**REVISED PRELIMINARY OVERALL
AREA DEVELOPMENT PLAN
FOR
ESCONDIDO SUBDIVISION**

INFORMATION SHEET FOR
PRELIMINARY OVERALL AREA DEVELOPMENT PLAN
(P.O.A.D.P.)

RE: Escondido POADP
File # 85-11-63-28
Revised: 8/19/86

Re: Escondido Preliminary Plan
 P.O.A.D.P.
File #: 85-11-63-28

preliminary overall area development plan

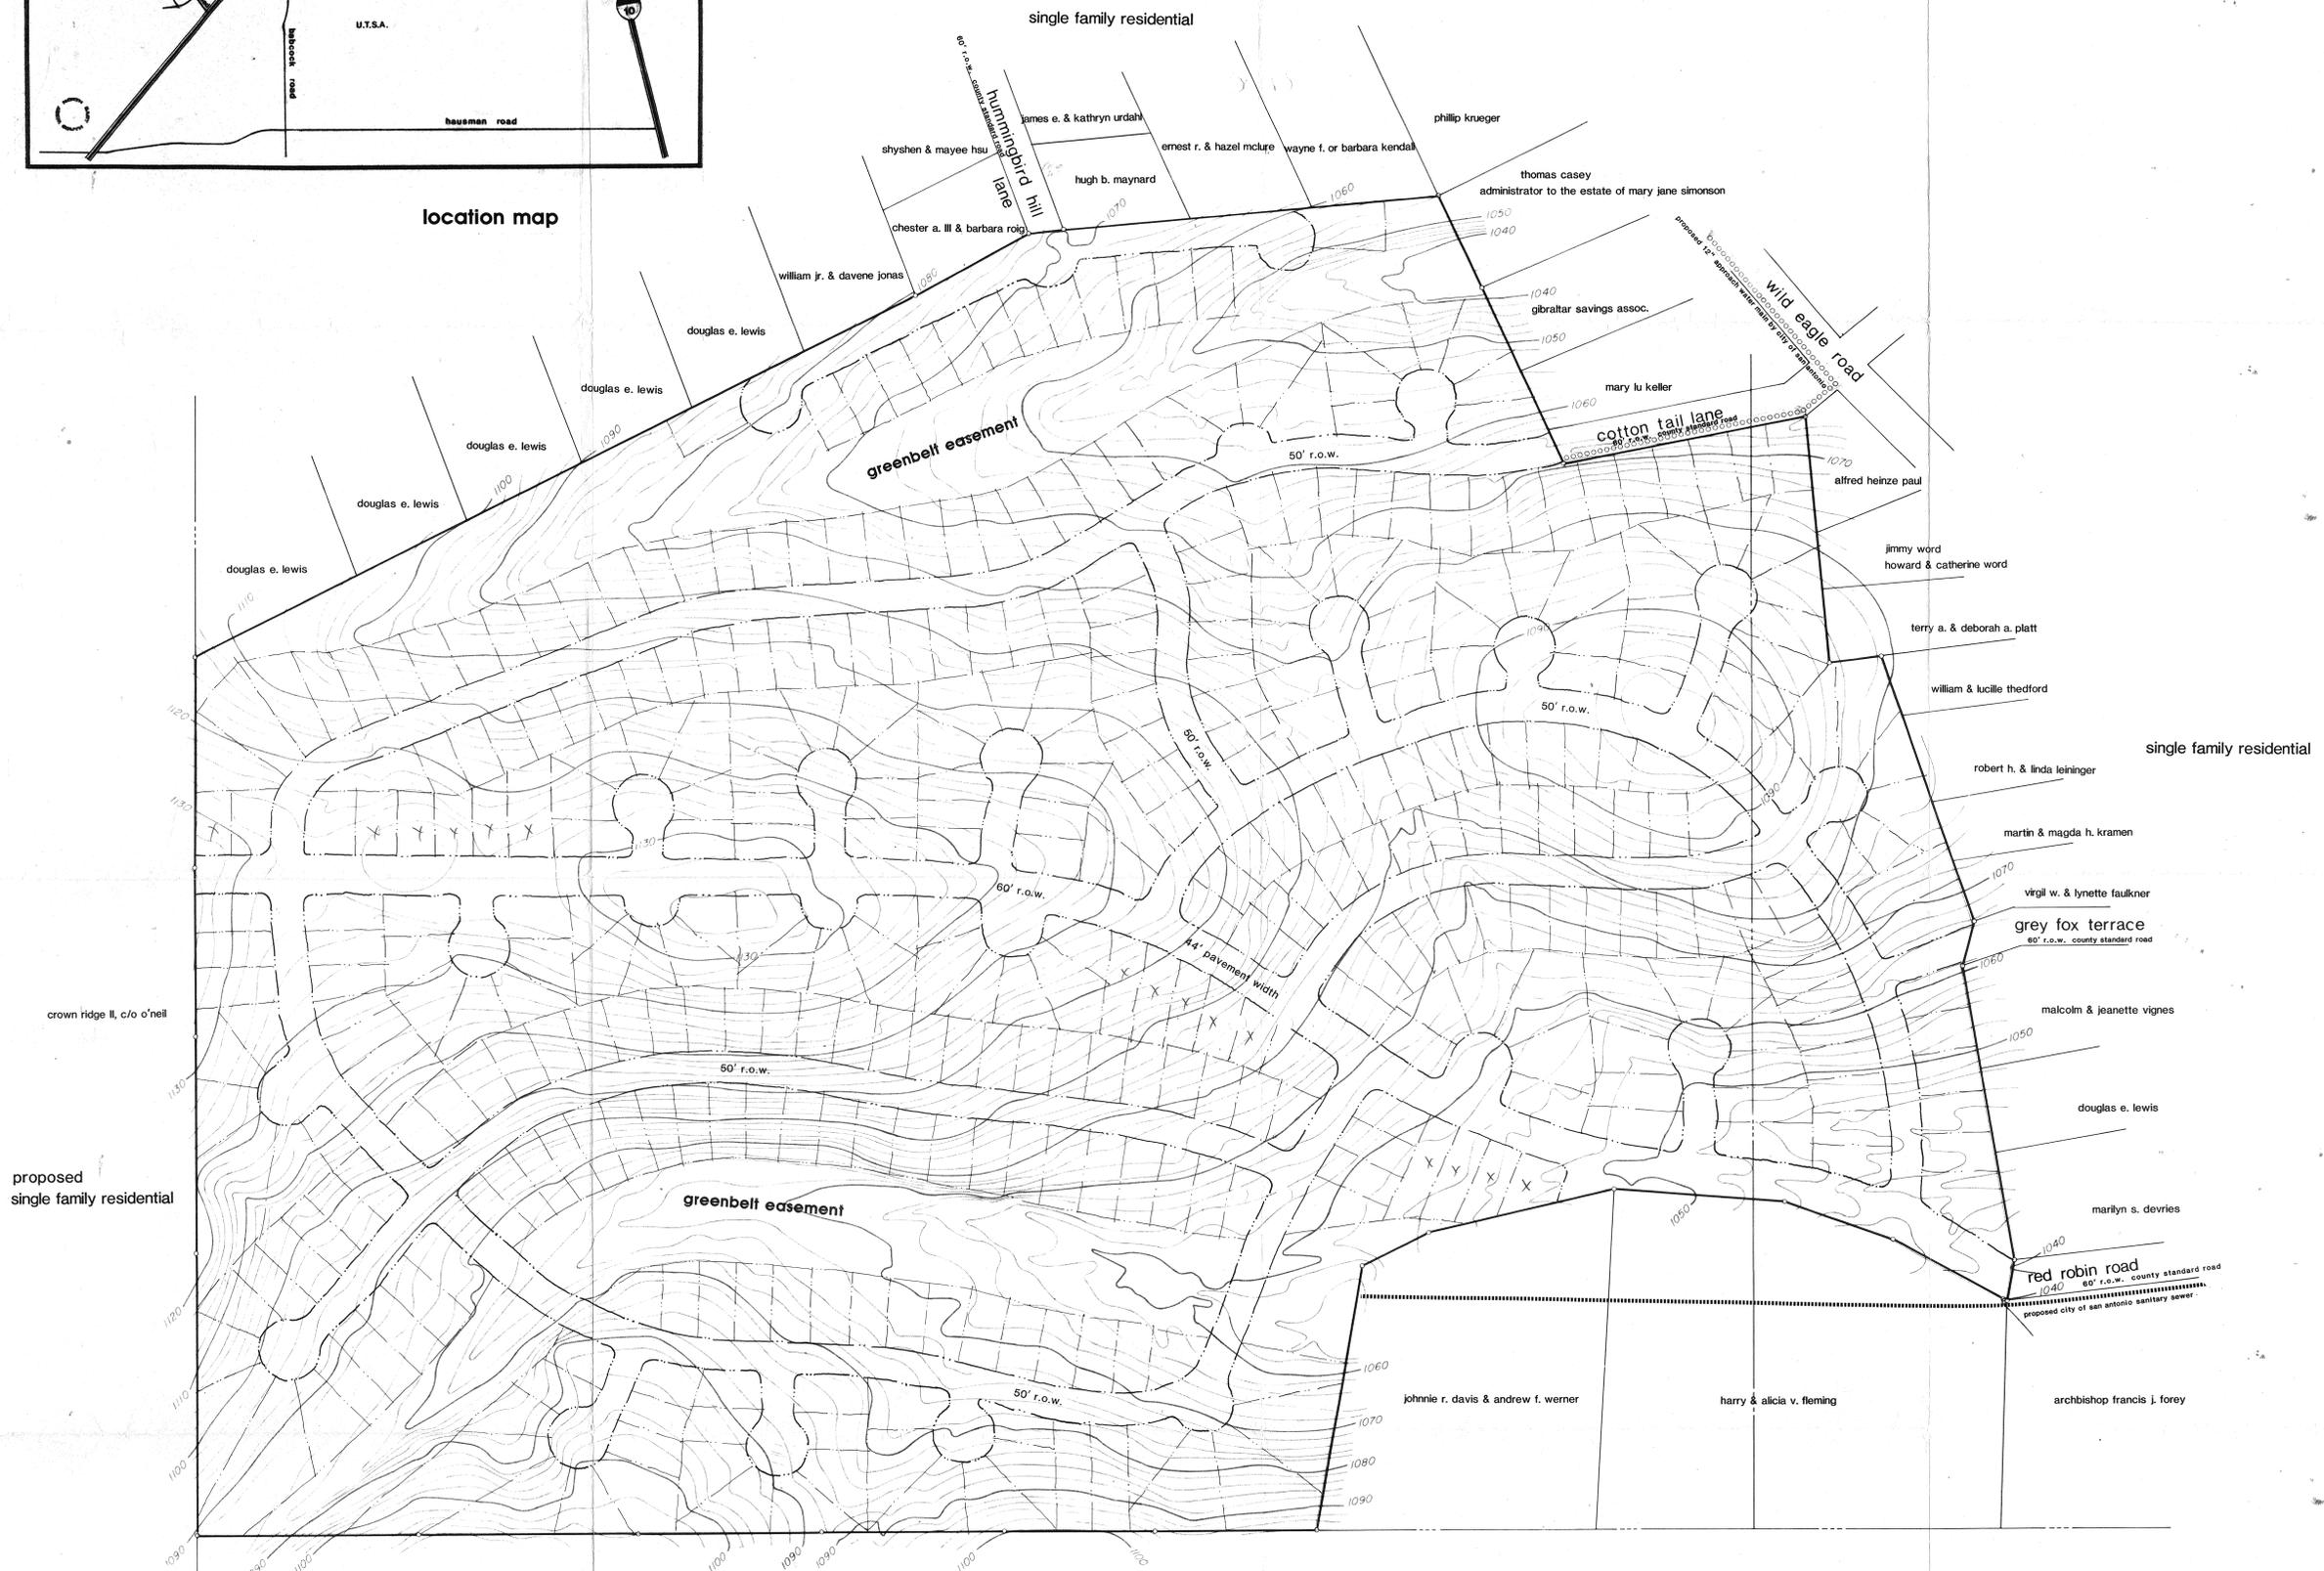
- () See annotations/comments on attached copy of your plan.
- (X) Comments: Staff concurs with the 60' collector with 44' of paving and the overall plan. However, there is a concern to the 15 lots fronting onto said collector. Staff suggest that an alternative design be submitted to discourage lots from having direct access to the collector.
